APPROVED
Limited building only review
Permit holder responsible for full compliance with the code

RESIDENCE OF MS. STACEY WALKER

DRAWING NUMBER
W-2477

FRONT ELEVATION

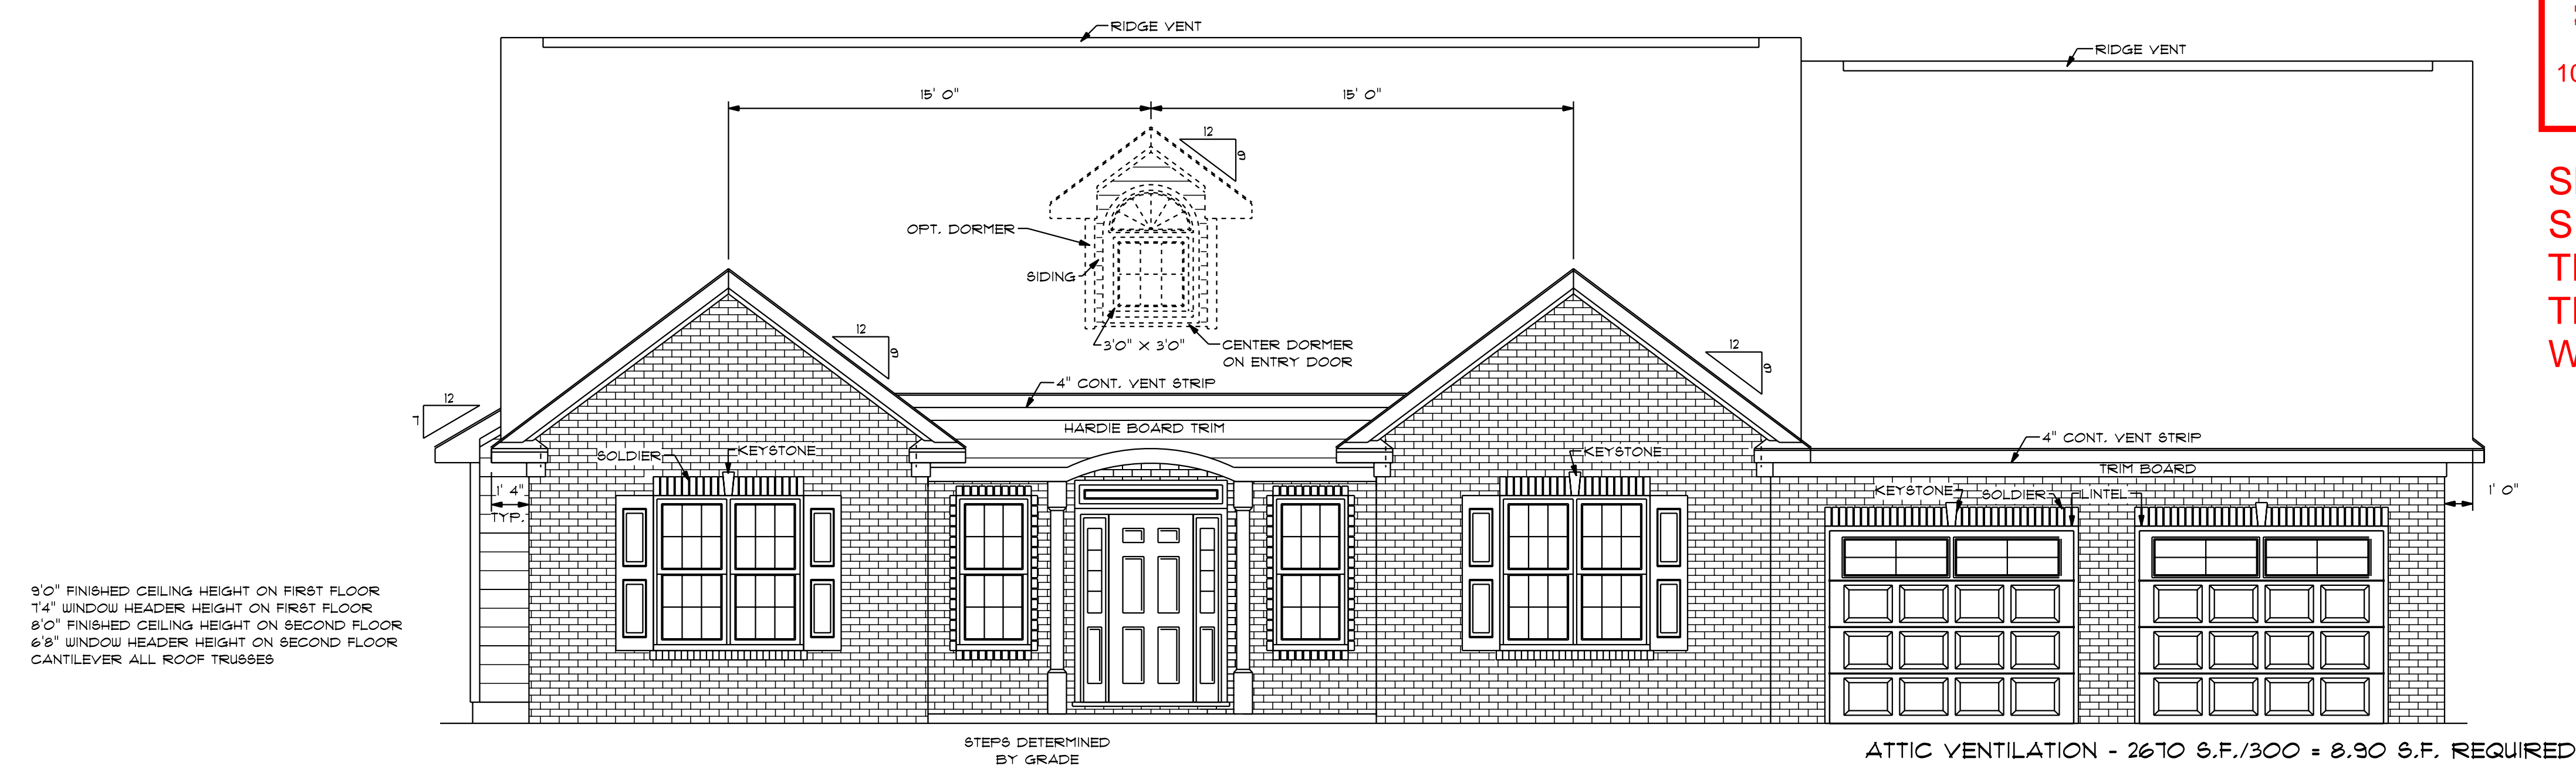
**SLAB MUST BE INSULATED
SEE NOTES ON GIRDER
TRUSS SUPPORT. LARGE
TRUSS POINT LOADS SHOWN
WITHOUT SLAB SUPPORT.**

FOUNDATION PLAN
 SCALE: 1/4" = 1'0"

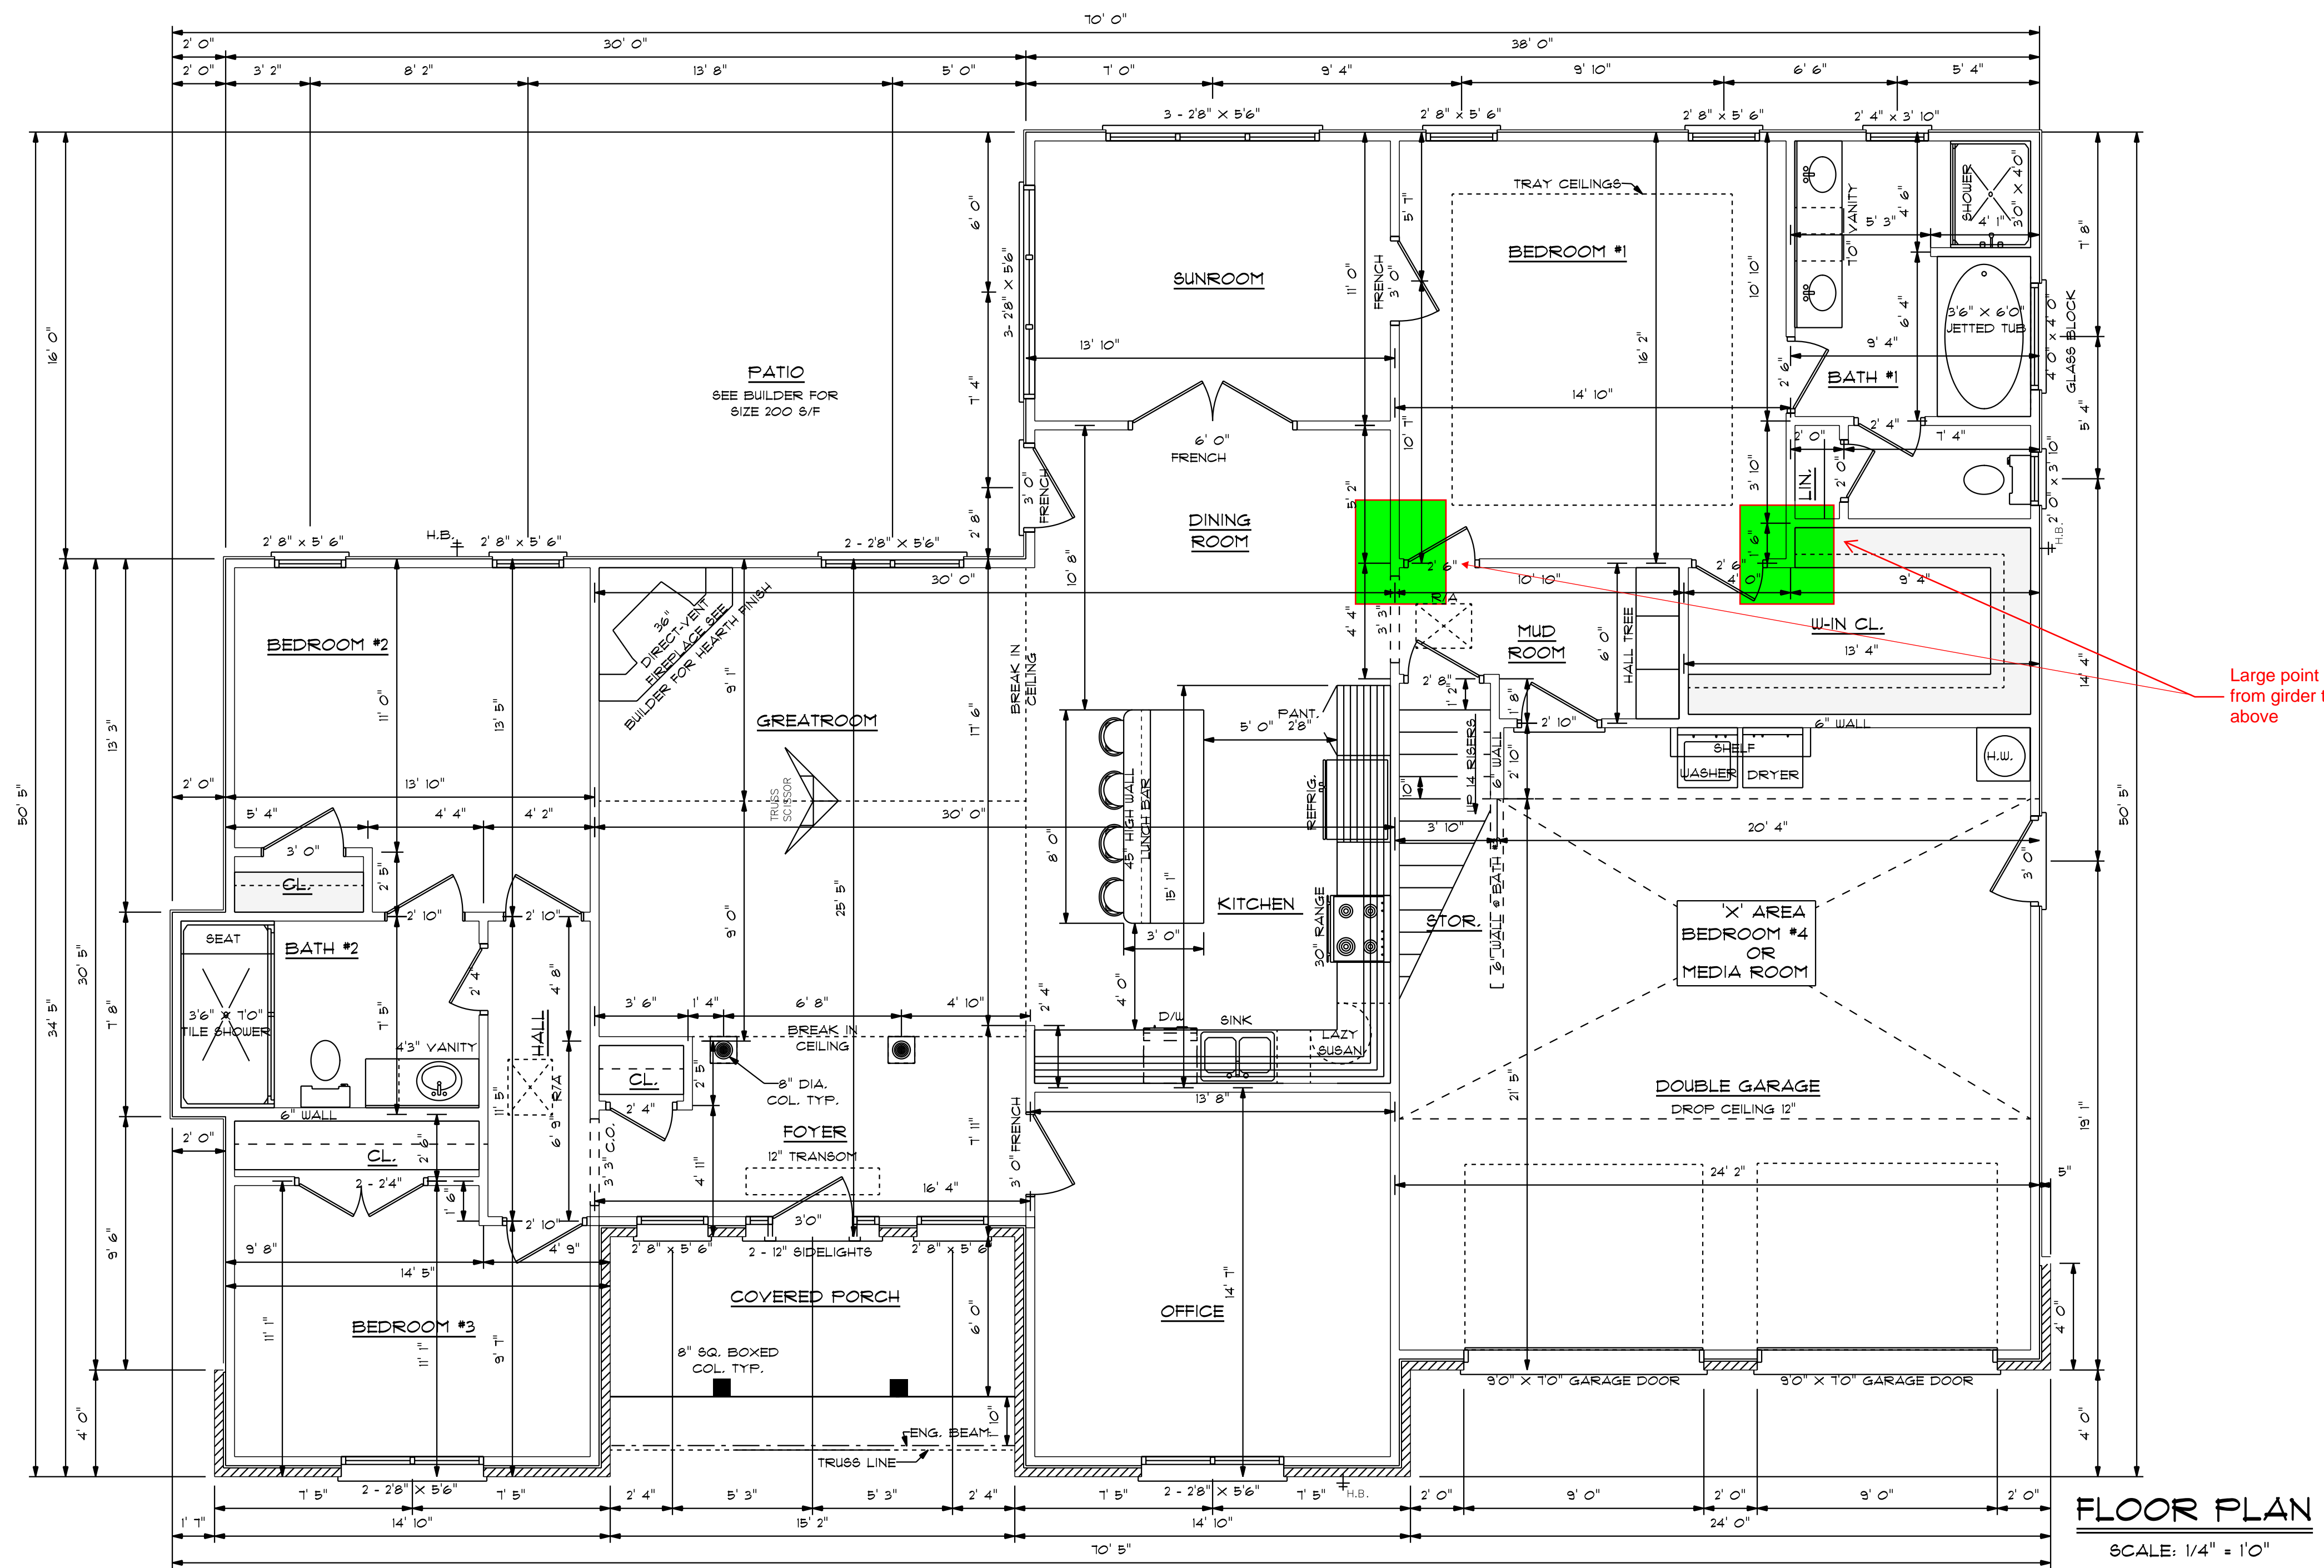
**SLAB MUST BE INSULATED PER CODE.
 SLAB MUST BE MONOLITHIC PER CODE
 ADDED FOOTINGS MUST BE INSTALLED AS SHOWN**
